March 22, 2021

Town of Hingham
Planning Board
210 Central Street
Hingham, MA 02043
(Submitted Electronically via Email)

**RE: 100 Industrial Park Road – Amazon Last Mile Facility
Comments/Questions Regarding Special Permit A3 Parking Determination & Waiver**

2 RETURN DESK SECTION - SLOT
1 1/2" = 1'-0"

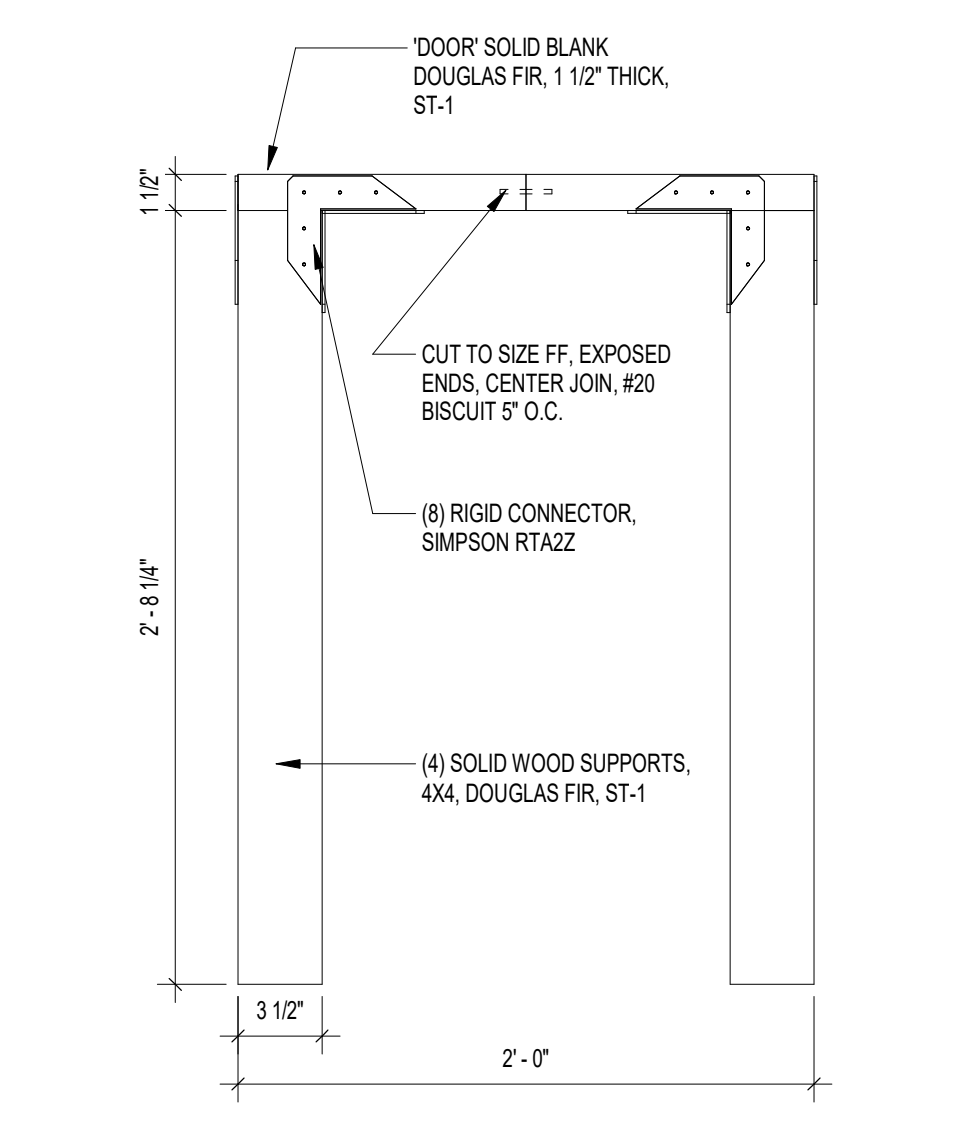
- See attached copies of sheets A1.02 and A11.03 (Attachment A) prepared by BL Companies that are on file with the Hingham Building Department as part of the pending Building Permit Application(s).
- The BL Companies Building Plans identify and detail a “Tenant Hub.” The detailed views of this hub clearly identify “Customer Kiosks” as well as “Customer Pickup Lockers” and package “Return Slots.”
- We ask what parking requirements have been determined for this public-facing element, where spaces have been provided and what provisions are provided for directional signage to direct the public accordingly?
- Why have no vehicle trips for this use been accounted for in the Supplemental Traffic Information report dated February, 2021?
